## CALIFORNIA COASTAL COMMISSION

STAFF REPORT: APPEALSUBSTANTIAL ISSUE

LOCAL GOVERNMENT:	City of Crescent City
DECISION:	Approval with Conditions
APPEAL NO.:	A-1-CRC-02-150
APPLICANT:	Beth M. Forest Trust
AGENT:	Tom Kraft
PROJECT LOCATION:	1100 South Pebble Beach Drive, Crescent City, Del Norte County, APN 118-300-03.
PROJECT DESCRIPTION:	Construction of a 2,850-square-foot, 1- to 2-story, 13- to 25-foot-high, single-family residence with attached garage.
APPELLANTS:	Louise Campbell, Arthur R. Lewis, Michael Scavuzzo, and Marvin & Carol Root
SUBSTANTIVE FILE: DOCUMENTS	1) City of Crescent City CDP File No. 2001-02; and 2) City of Crescent City Local Coastal Program

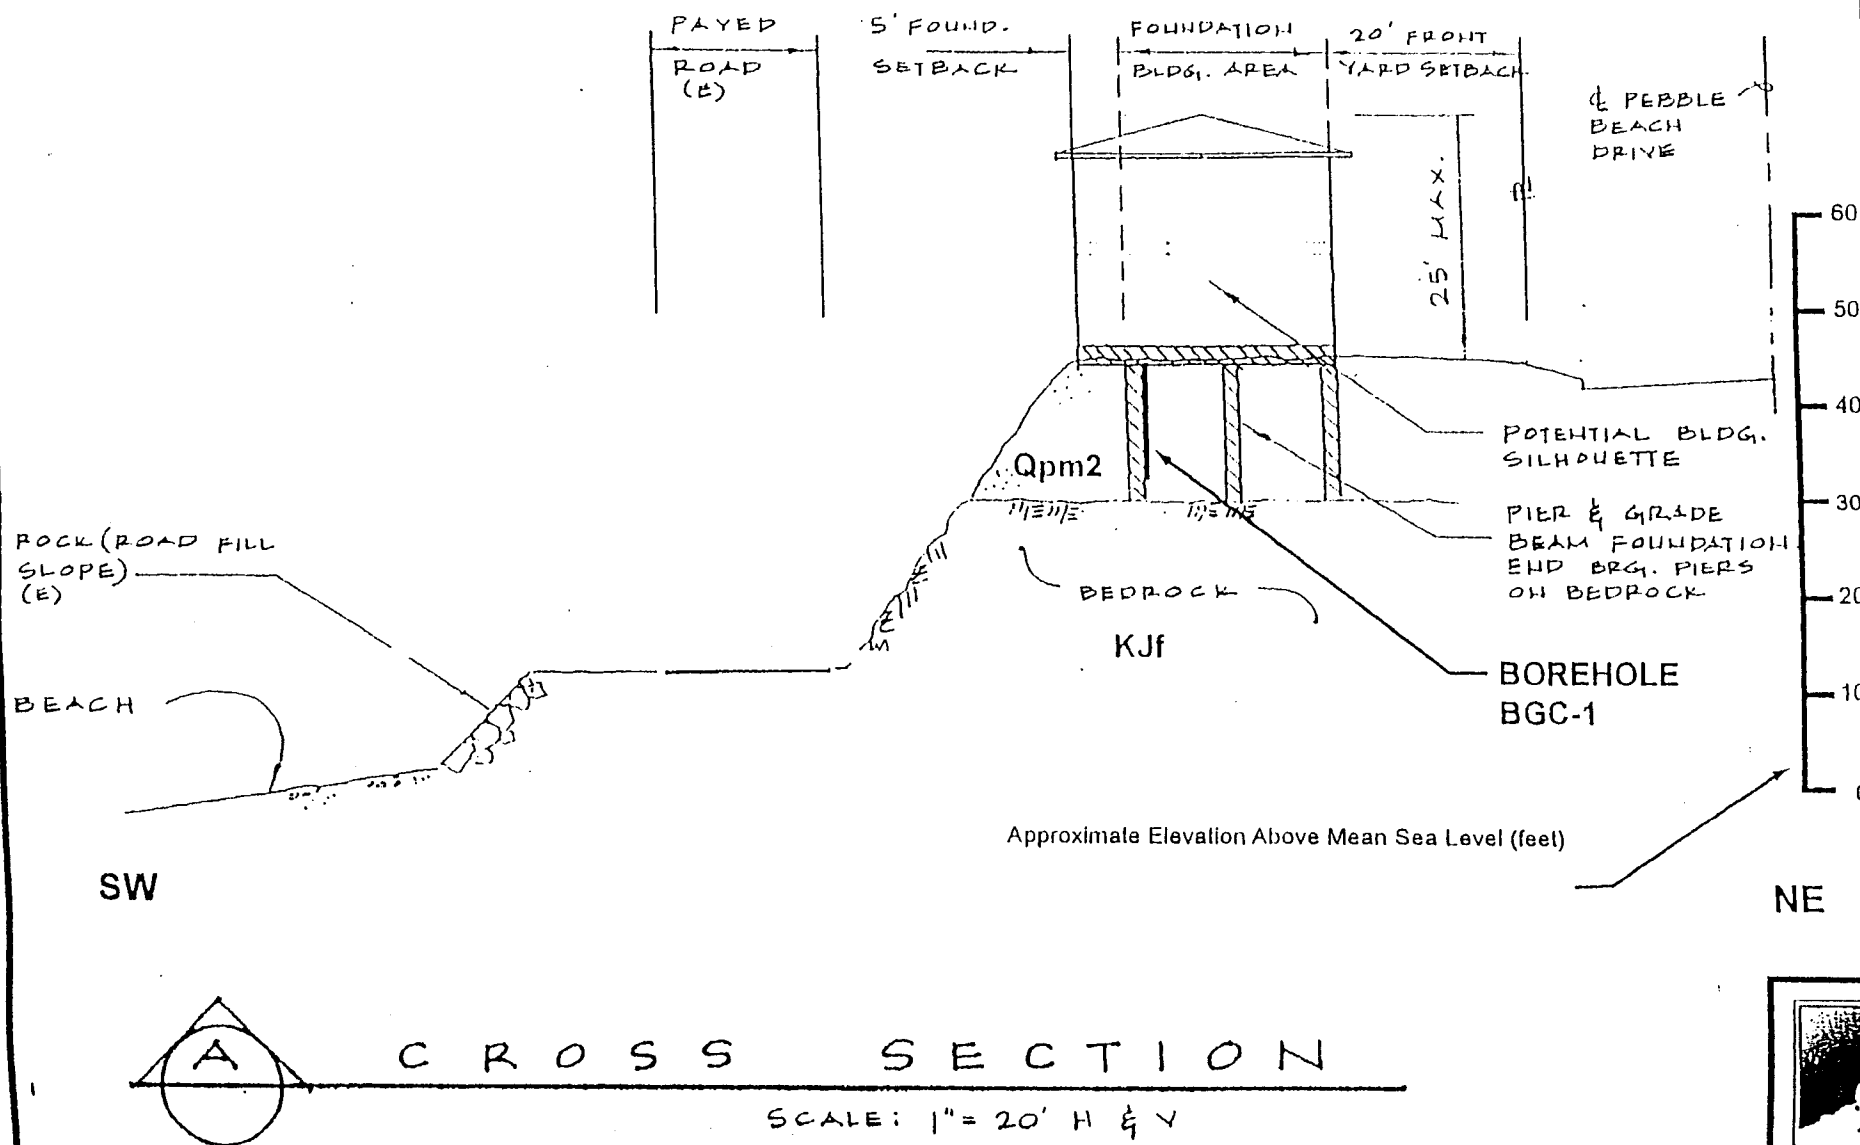
**Global Stability.** Based on our review of the reports by others, we are in general agreement with the statements regarding a low risk of damage due to global or large-scale slopes failures. However, we were unable to find any indication that the orientation, frequency and severity of rock fractures or bedding planes were considered in large-scale stability during a moderately large seismic event. Adverse bedding planes which dip out of the cut slope or natural sea cliff or other discontinuities in the rock mass that cause

weak planes, can create an unstable situation during a seismic event. Unless data is available on the fracturing and bedding, it would be prudent to obtain and evaluate such data. The presence of adverse bedding planes or severe fracture patterns may require rock bolting or other method of preventing large-scale instability of the parcel during a moderately large seismic event.

In conclusion, the homesite is veneered with ~2 ft of native topsoils overlying ~11 ft of sandy subsoils. Although the subsoils are suitable foundation-bearing soils, the proposal to bear the home on piers anchored to bedrock is prudent to protect against a greater-than-predicted Csz earthquake event (see Figure 5, following discussion, and REC 2).

5 most critical surfaces, MINIMUM JANBU FOS = 1.314

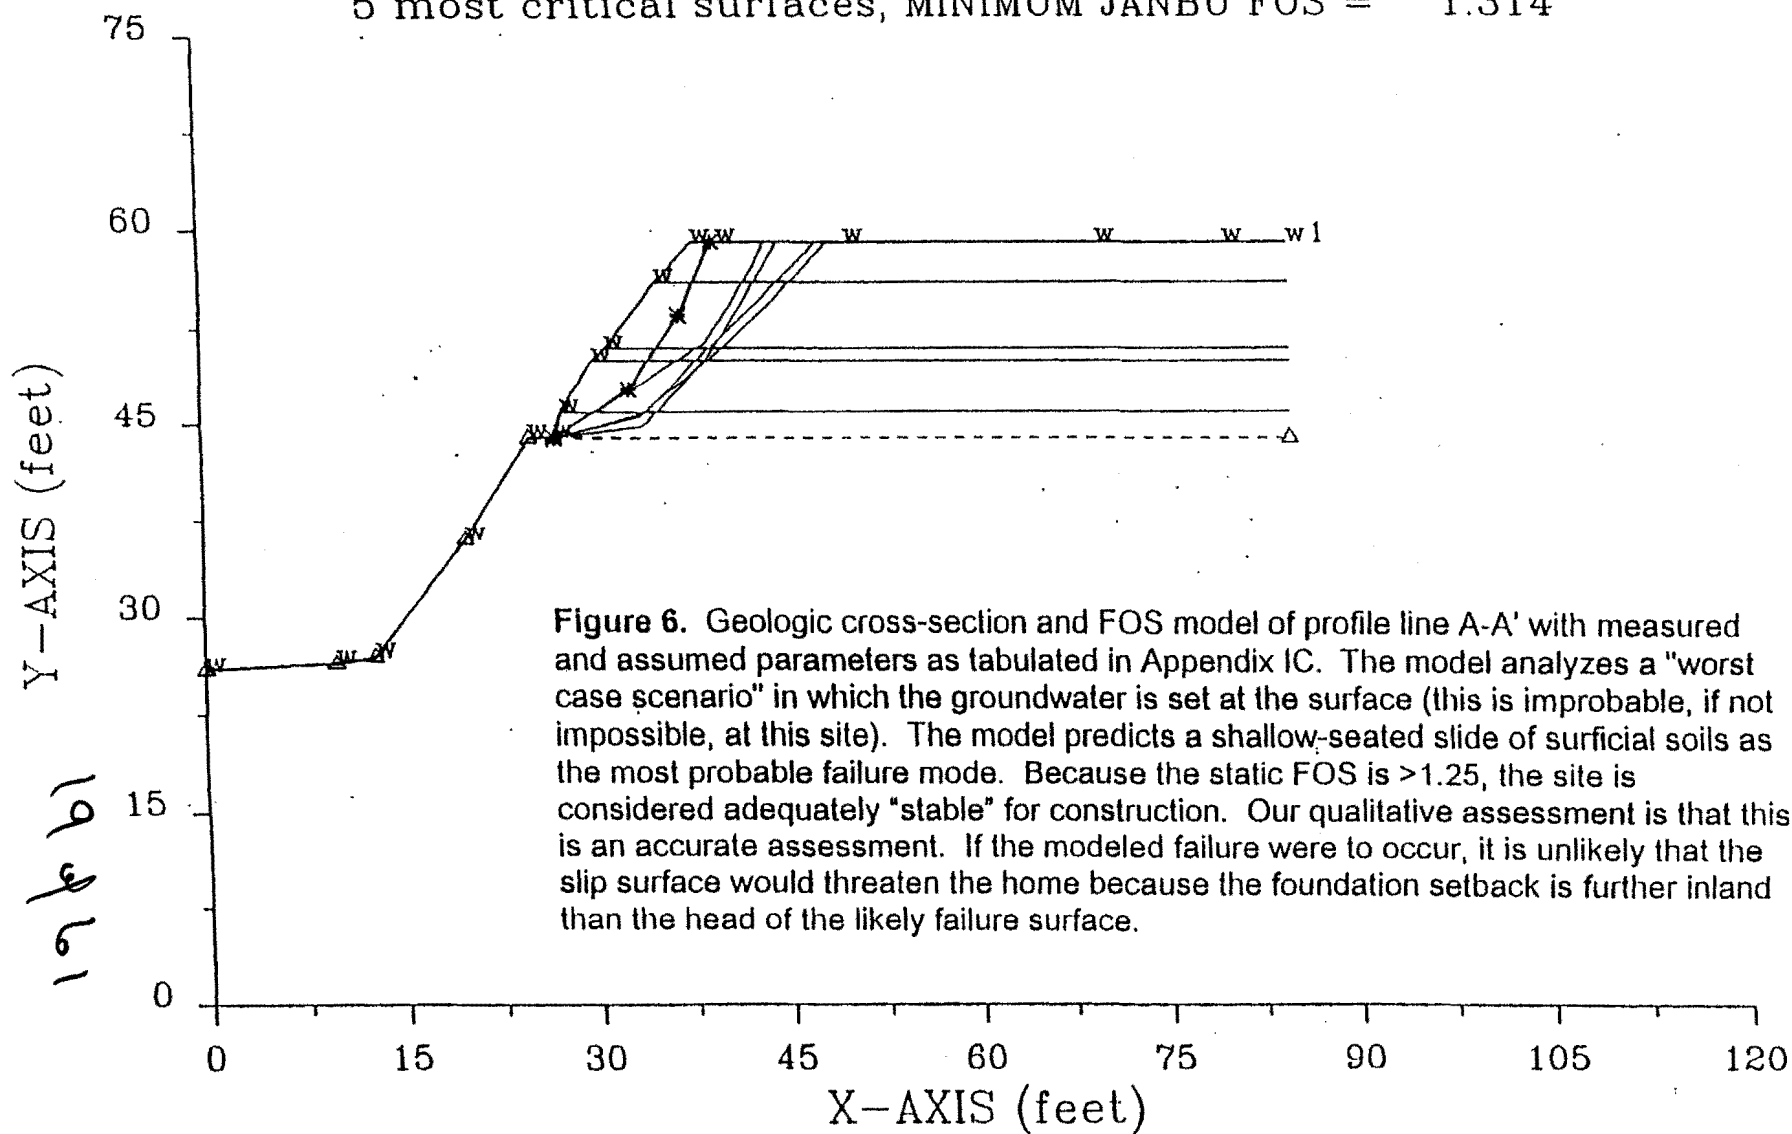
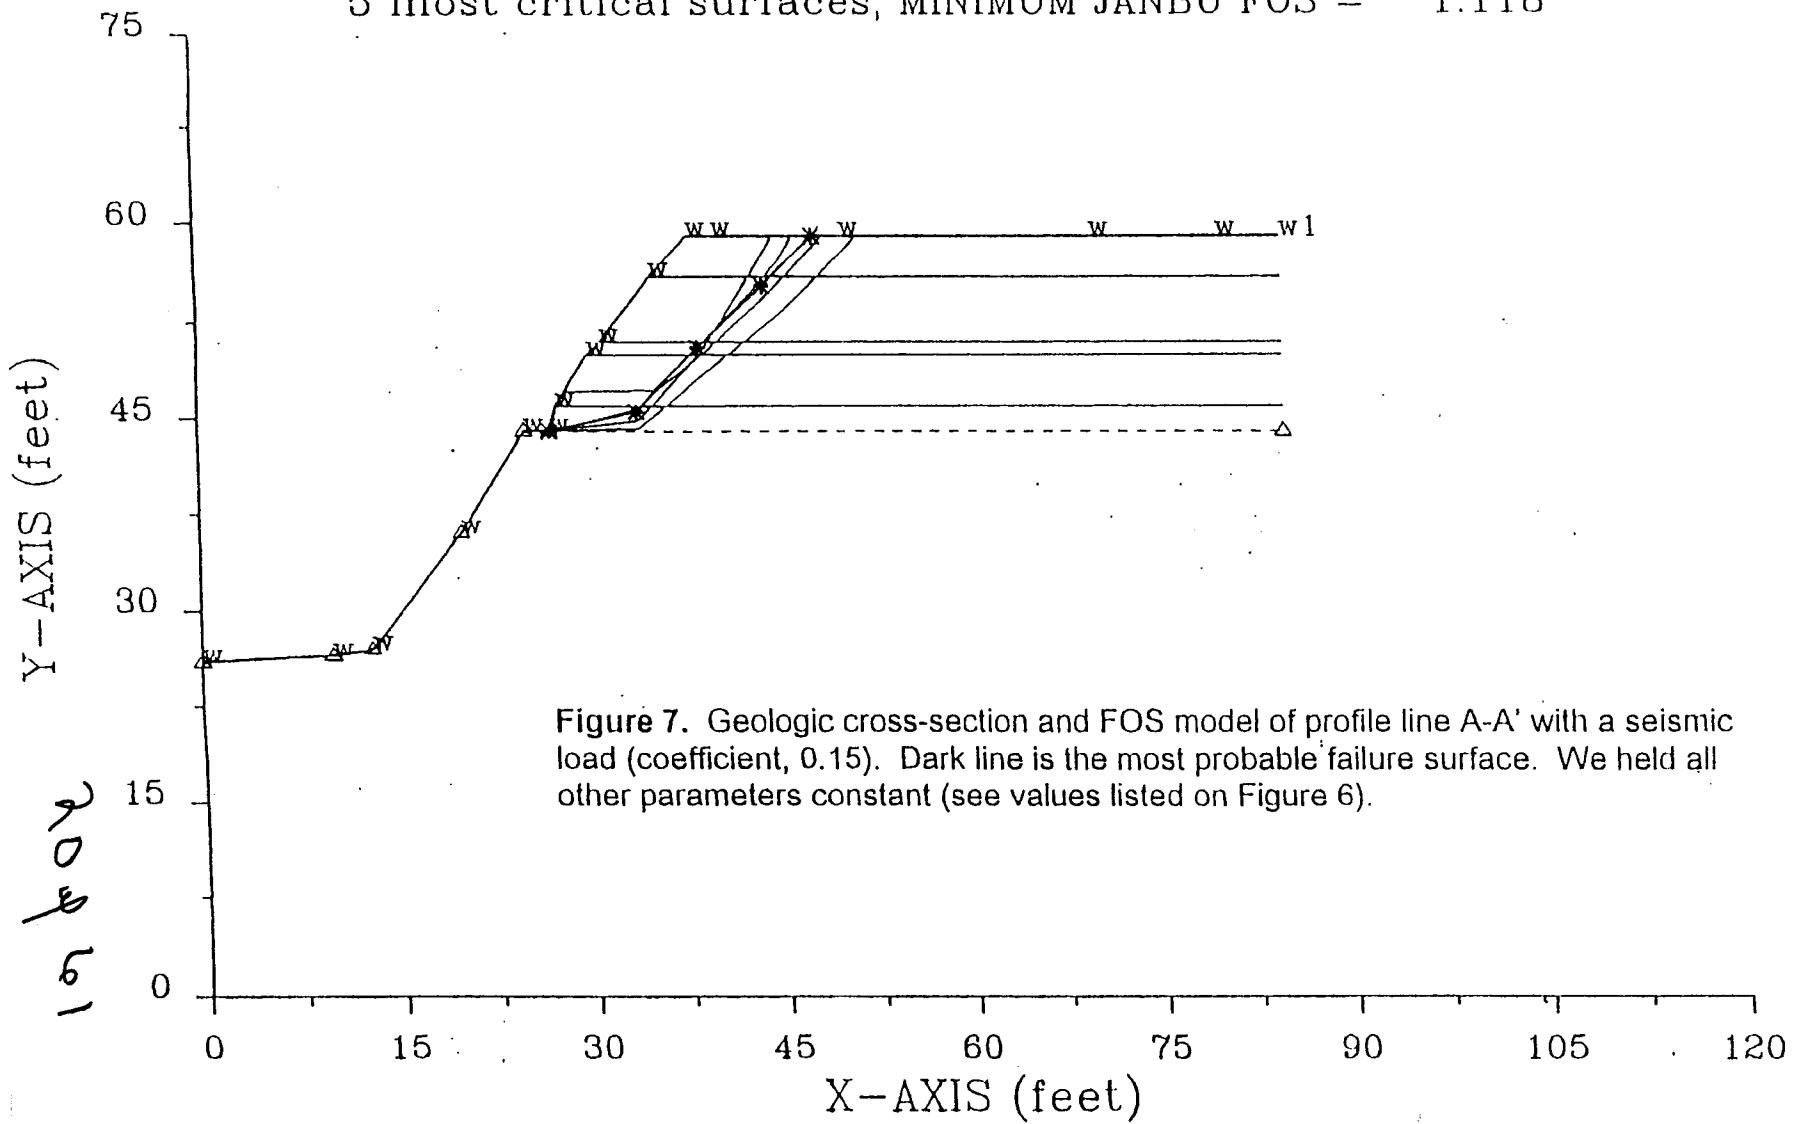
The appellants question whether the stability assessment within the BGC geotechnical report adequately considered the hazards associated with erosion of the soils overlying the blufftop due to the exposure of the site to extreme precipitation. In addition, the appellants also express their doubts whether the presence of groundwater or sub-surface aquifers were allowed for and how they might affect bluff retreat. The appellants further raise concerns that the BGC report did not sufficiently take into account the effects of repeated seismic shaking and/or blasting associated with the quarrying of rock from Preston Island may have on the site stability. Furthermore, the appellants assert that the applicant's geologist did not effectively consider that the conclusions and recommendations within the geotechnical report were based on inconclusive and sparse data and did not identify other mitigative actions for protecting the site. As a result, the appellants argue that the long-term stability of the project site and its surroundings was not sufficiently addressed, inconsistent with the requirements of the LCP. The appellants cite language contained within the introductory section of the LUP's Diking,

Figures 6 and 7 graphically present the results of our preliminary FOS analysis of the critical profile using the slope geometry, stratigraphy, and water table shown on the figures. The soil parameters we used are listed in Appendix IC. We do not show or discuss constraints (such as failure segment length) that we input into the program. Each figure illustrates the five most probable failure surfaces for the conditions evaluated. The failure surface with asterisks is the surface with the lowest factor of safety, which is stated on the figure. Figure 6 models static conditions with the point of origin (toe) of the landslide forced between  $x = 27$  and 38 feet (from the arbitrary point of origin). Figure 7 models dynamic conditions (earthquake shaking conditions) with the seismic coefficient,  $k$ , equal to 0.15; the model uses the same soil parameters as Figure 6.

- 1, the most probable slope failure mode is shallow landsliding of weathered surficial soils on the face of the bluff (see Figure 6);
- 2, on the critical profile,  $FOS_s = 1.31$  and the failure sole intersects the ground surface ~2 feet east of the break-in-slope, well west of the house footprint; and
- 3, on the profile line,  $FOS_d = 1.11$ , extending ~10 ft east of the break-in-slope, which would lie within the house footprint (Figure 7).
